Office Action Summary

10/527,967

AMBROSI, JOHANN

DETAILED ACTION

(Horimoto Figure 19)

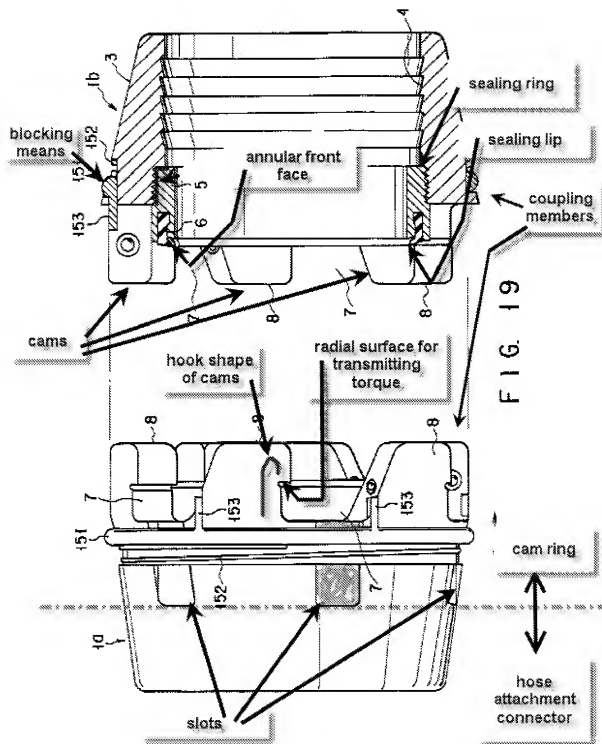
At the outset, it is noted that the ninth embodiment of the invention of Horimoto, as shown in Figures 18-19, is identical to the sixth embodiment, as shown in Figures 9-14, with the exception of the lock mechanism and associated structure (column 13, lines 14-18).

In regard to claim 1, Horimoto discloses in Figure 10 and Figure 19, the figures shown below, a symmetrical hose coupling comprising

a pair of like coupling members (1a and 1b, as observed in Figure 19, below),

each of the coupling members having a cylindrical hose attachment connector (4) and a cam ring integrally formed with the cylindrical hose attachment connector (as observed in Figure 19, below), the connector having an outside diameter (the connector of Horimoto has numerous "outside" diameters, and as such, the Examiner arbitrarily chooses the "outside diameter" directly adjoining the "slots" noted in Horimoto Figure 19, shown below),

the cam ring having a plurality of integral cams (8) arranged on the periphery of the cam ring and projecting from the cam ring (the slots noted in Figure 19, below and in Attachment A, result in the cams projecting radially from the cam ring - the blocking means appears to be positioned by the slots - note that the slots "bottom", radially inner surface, is the outer radial surface of the cam ring), the cams projecting radially beyond the outside diameter of the cylindrical hose attachment connector for defining the largest outside diameter of the coupling (the Examiner notes that the "blocking means" shown in Figure 19, below, is a part added onto the coupling of Horimoto and, as such, is not a required part of the coupling nor is the "blocking means" a requirement of the instant claim), the cams being hook-shaped in a tangential direction of the cam ring and each having a radial surface area (9 in Figure 10) for transmitting an axial force, and the cams of the coupling members engaging into each other during coupling such that the radial surface areas engage behind each other (the coupling members engage each other in the recited fashion as indicated in column 13, lines 19-34).

In regard to claim 10, Hiromoto discloses the claimed invention in the embodiment as shown in Figure 19, above, with the exception of a blocking means that does not project radially beyond the cams. The Examiner notes that Hiromoto does disclose that a blocking means (lock claws 153 as observed in Figure 19, above, and as disclosed in column 13, lines 19-34) is provided for locking the pair of coupling members with each other in a coupled condition; however, the disclosed blocking means of the embodiment shown in Figure 19 projects radially beyond the cams. Hiromoto teaches an alternative blocking means in Hiromoto Figures 9-14 (taught starting in column 9, paragraph 2, though column 12, first paragraph) which does not project radially beyond the cams. It would have been obvious to one having ordinary skill in the art at the time the invention was made to simply exchange the blocking means as disclosed by Horimoto in the embodiment shown in Figure 19 with the blocking means as taught by Hiromoto in relation to Figures 9-14 since they are functional equivalents.

Concerning the Applicant's discussion in 4-5 of the reply filed 05/19/2008 that the prior art of Horimoto (U.S. 5,857,713) fails to disclose "said cams projecting radially beyond the outside diameter of the cylindrical hose attachment connector for defining the largest outside diameter of said coupling" as required in instant claim 6, lines 6-7, the argument is not persuasive. First, claim 6 only recites "said connector having an outside diameter" (emphasis added) as a limitation to define the "outside diameter". As noted in the above rejection of claim 6, the connector of Horimoto has numerous "outside" diameters, and as such, the any one of the numerous "outside" diameters may be arbitrarily chosen to meet the claim language. For purposes of rejection, the Examiner has chosen the "outside diameter" directly adjoining the "slots" noted in Horimoto Figure 19, shown above.

Second, the Applicant is already aware that the "slots" shown in Figure 19, see above for visual clarification, are considered surfaces above which the cams extend. The Examiner noted this interpretation of the prior art of Horimoto in page 8, paragraph 4, of the Office action mailed 01/18/2008, and, further, it appears that the Applicant has simply chosen to dismiss such an interpretation of the prior art of Horimoto as indicated by the following statement from page 4, lines 14-16, of the reply filed 05/19/2008:

(close-up of Horimoto Figure 19)

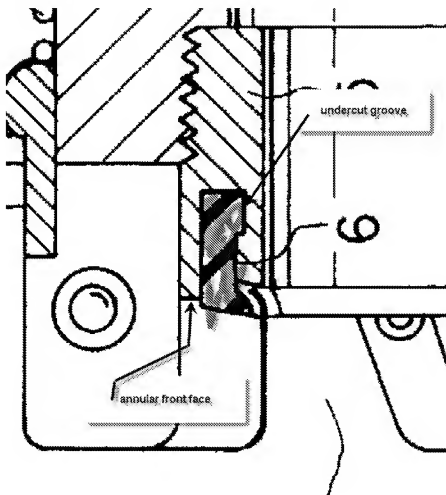
In regard to claim 8, Horimoto further discloses, in Figure 19, above, and close-up of Figure 19, below, that the cam ring has an annular front face radially inwardly of the cams and an annular undercut groove is recessed in the annular front face for receiving a shaped sealing ring having a sealing lip which protrudes axially beyond the front face of the cam ring.
